Docket Item # 1 & 2  
BAR CASE #2013-0013/0014

BAR Meeting  
February 20, 2013

**ISSUE:** Permit to Demolish/Capsulate and Certificate of Appropriateness

**LOCATION:** 416 N Union Street

**Figure 3: Example of a historic pedimented dormer and 2/2 windows**

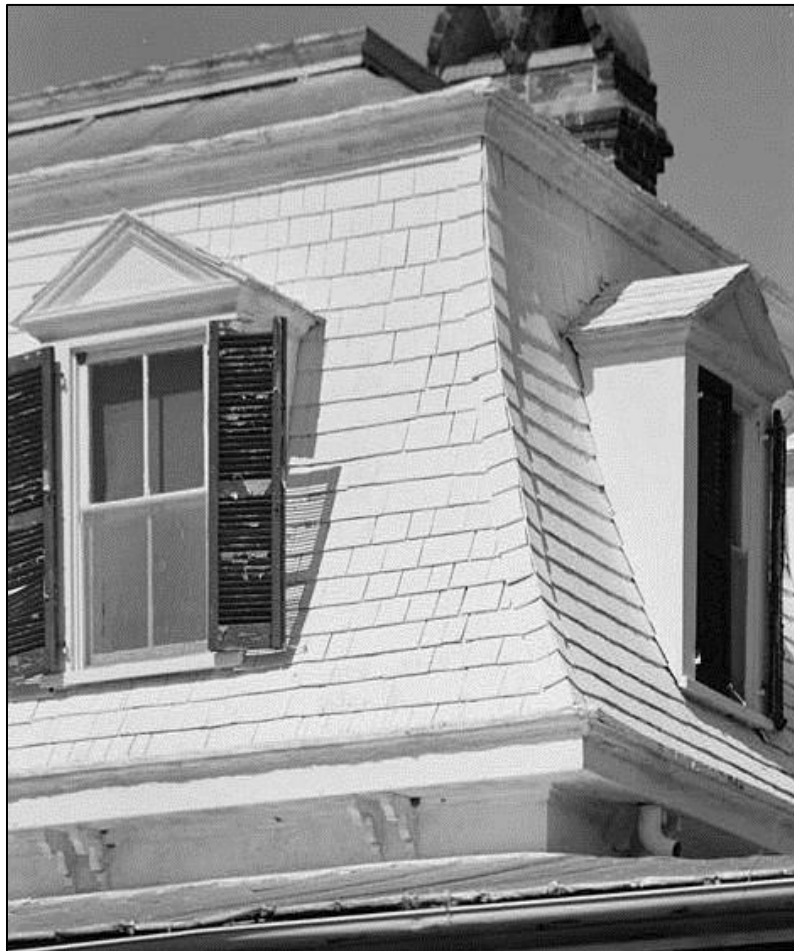
The *Design Guidelines* and the Board’s *Window Policy* support the use of a aluminum-clad wood, simulated divided light windows on buildings constructed after 1969, however in this situation, since all the windows are not being replaced, it is recommended that the muntin width of the new windows match the existing windows 5/8” muntin width. In addition, since the house is being converted into a Neo-Victorian, it is the strong preference of the Board, that architectural elements of a particular style not be mixed and matched on modern or historic buildings within the district, therefore, it is recommended that when the owners elect to replace the existing windows on the house in the future, that the windows be replaced with a 2/2 window configuration - a more compatible window treatment for the Second Empire style.

5. That when/if the owners elect to replace the existing windows on the house in the future, that the windows be replaced with more compatible 2/2 window configuration.

**A3**

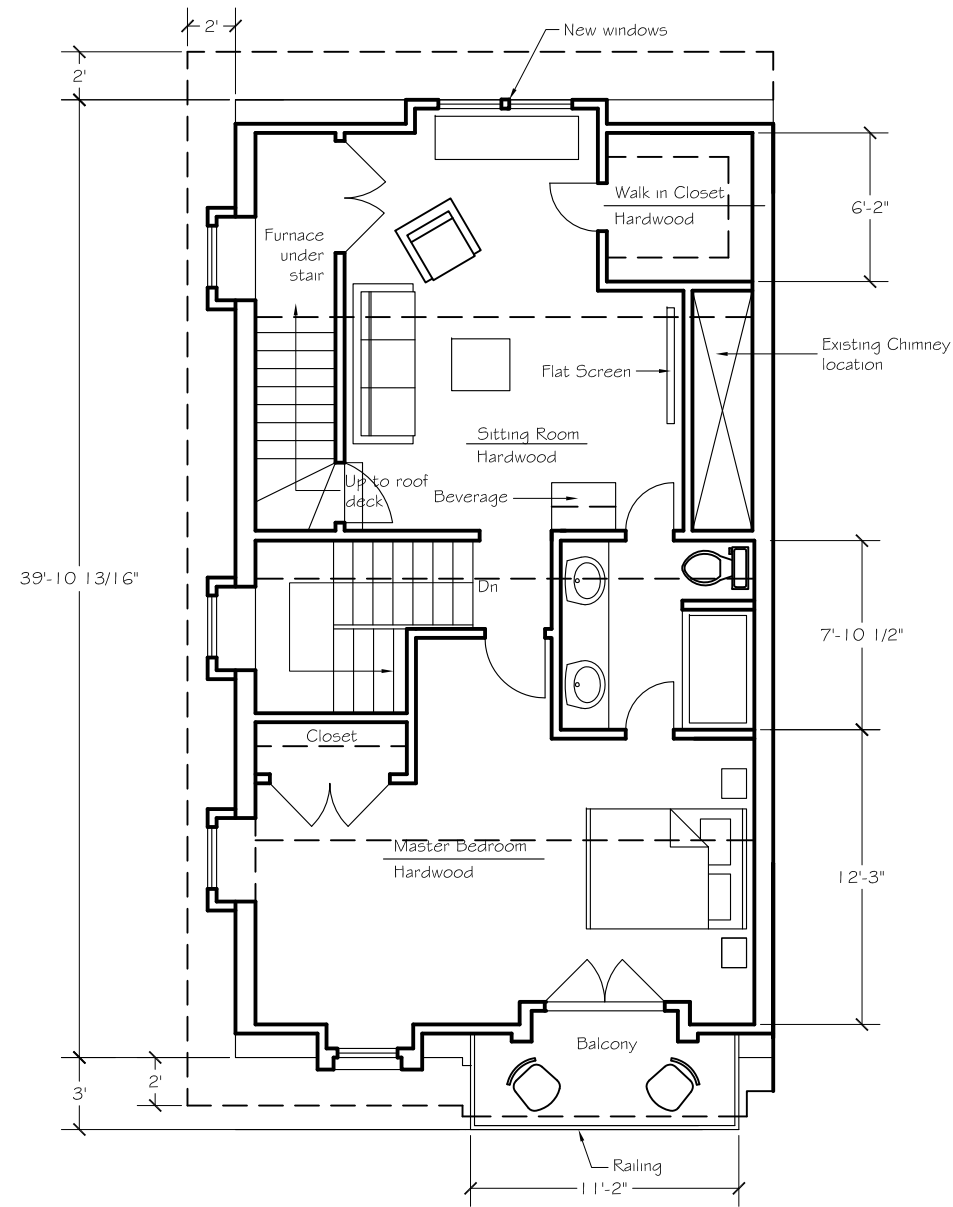
4. Construct a pedimented dormer with a 6/6 SDL aluminum-clad wood window, a pedimented dormer with a pair of 15-light SDL, aluminum-clad wood French doors and a 3' x 11'-2" balcony detailed with a 3' high composite "sawn" balustrade supported by decorative brackets on the east elevation.

Staff notes that the cornice along the top edge of the parapet abutting the adjacent neighbor appears to extend beyond the property line. Staff recommends that the architect verify that it does not extend beyond the property line or obtain an easement from the neighbor (which Staff recommends) prior to submission of construction permit drawings. Finally, it is recommended that the construction drawings include design details for the cornice and parapet for final review by Staff to insure that they are compatible with the proposed new architectural style.

The *Design Guidelines* state that “dormers should align with the existing windows or be centered between the windows.” Historically, “dormers are generally tall and narrow with minimal trim at the sides of the windows.” The applicant is proposing to add pedimented dormers to the front, side and rear elevations clad in HardiePlank siding with a five inch reveal and sheathed in metal or faux slate. Based on the elevation drawings, the dormers appear to have slightly different detailing on each elevation. Therefore, it is recommended that the architect work with staff to refine the dormer’s detailing prior to the submission of construction permits.

C-1 Proposed addition appears to comply with zoning. The flat top of the mansard style roof slopes ever so slightly towards the rear and acts a ridge facing the street, therefore the height of the of building cannot exceed 45 feet.

1. That the final design details for the dormers, cornice, parapet, roof and balcony balustrade, and the brackets be approved by Staff;
2. That all proposed materials be in conformance with BAR policies and be reviewed and approved by BAR staff prior to submission of construction permit drawings.

6. That the muntin width of the new windows match the existing windows 5/8" muntin.
7. That the cornice along the top edge of the parapet abutting the adjacent neighbor may not extend beyond the property line unless the applicant obtains an easement prior to submission of construction permit drawings.

**A4**

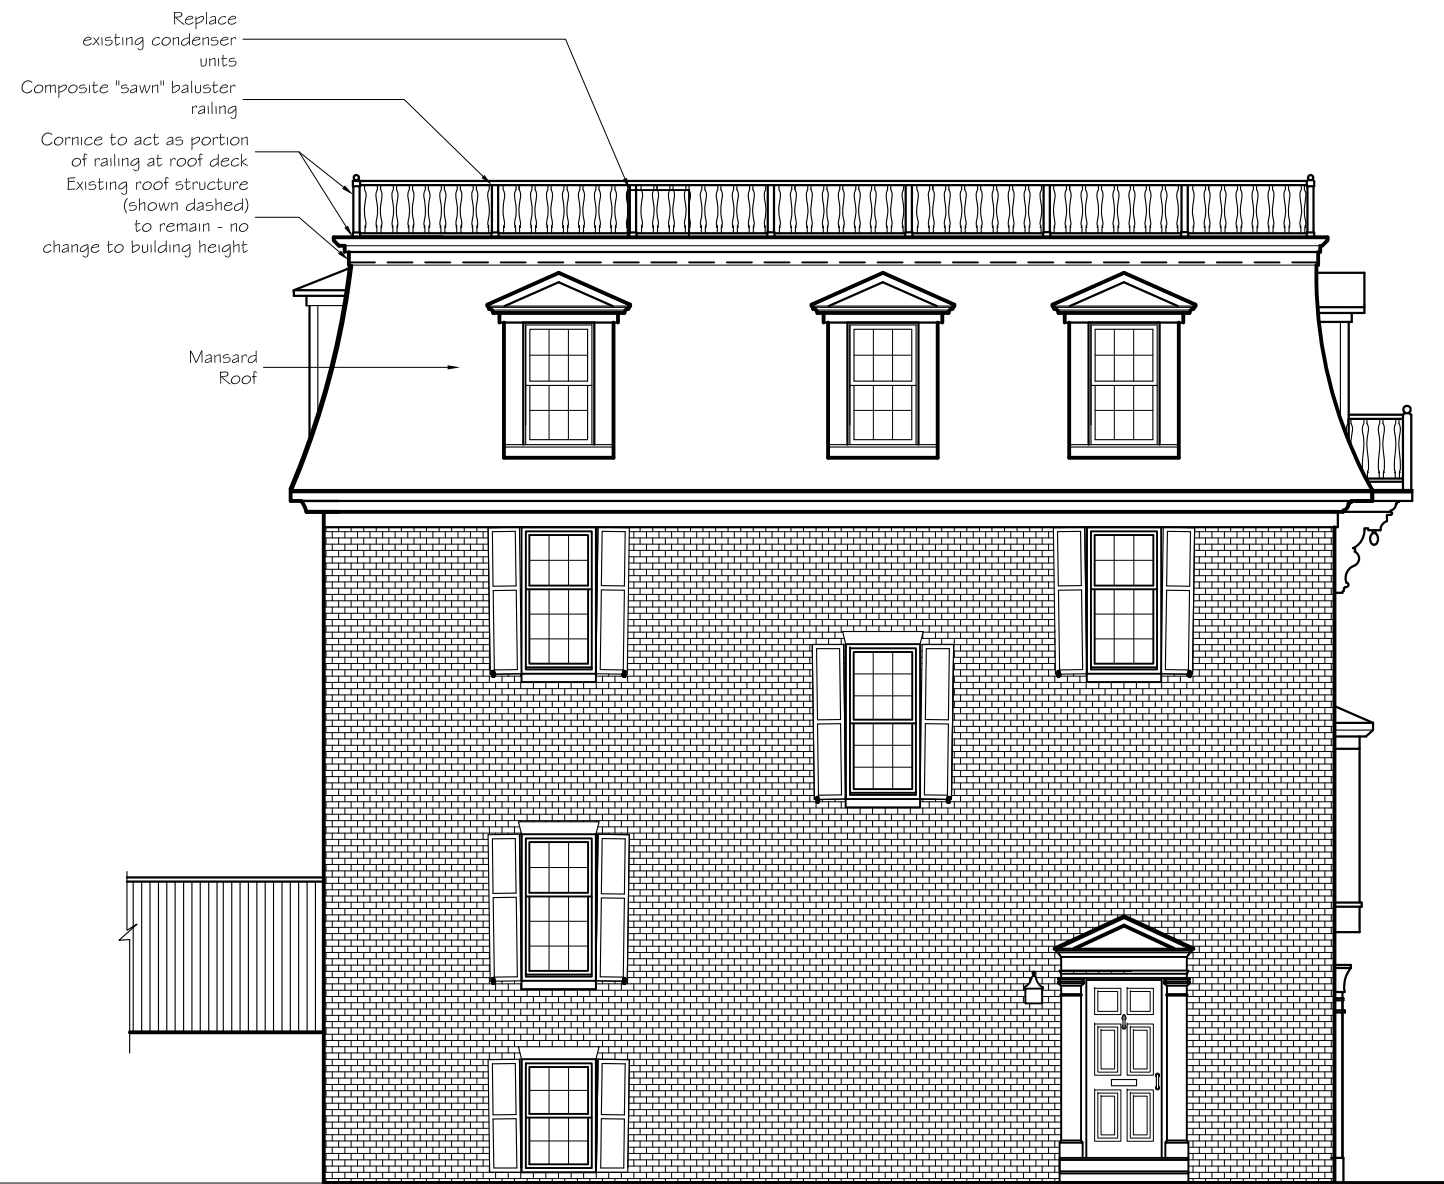
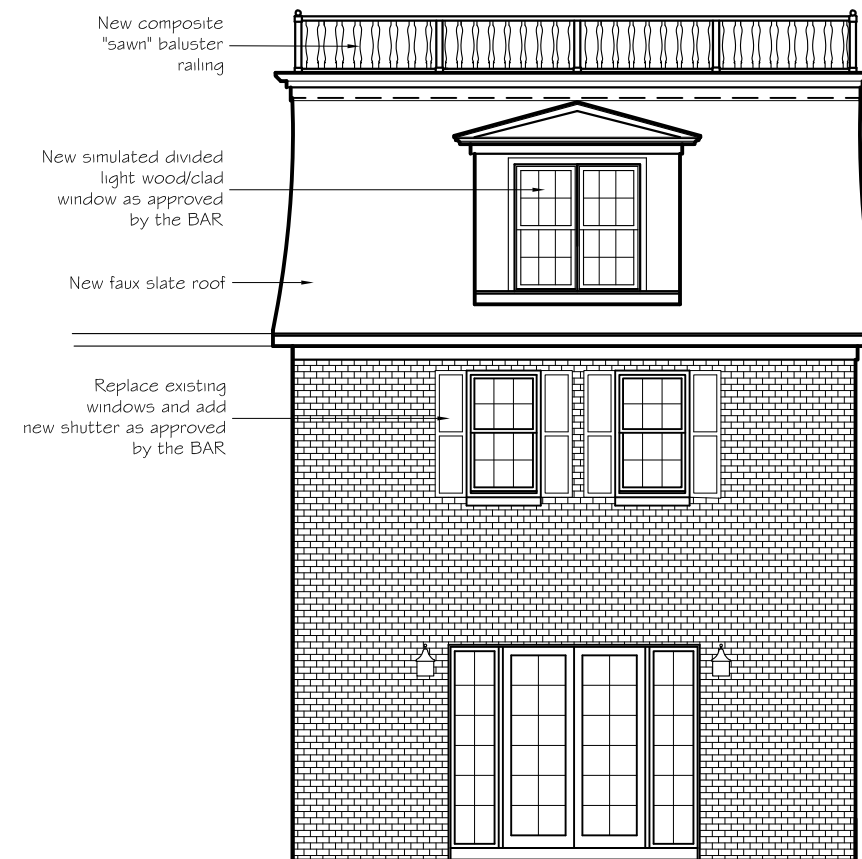
5. Install a composite garage door surround, to visually align the garage with the other fenestrations on the façade.
6. Construct pedimented dormers with 6/6 SDL aluminum-clad wood windows on the south elevation.

7. Construct a pedimented dormer with a pair of 6/6 SDL aluminum-clad wood windows on the west elevation.
8. Replace the existing 6/6 windows and wood, affixed to the wall shutters on the west elevation with new 6/6 SDL aluminum-clad wood windows and wood composite, affixed shutters.
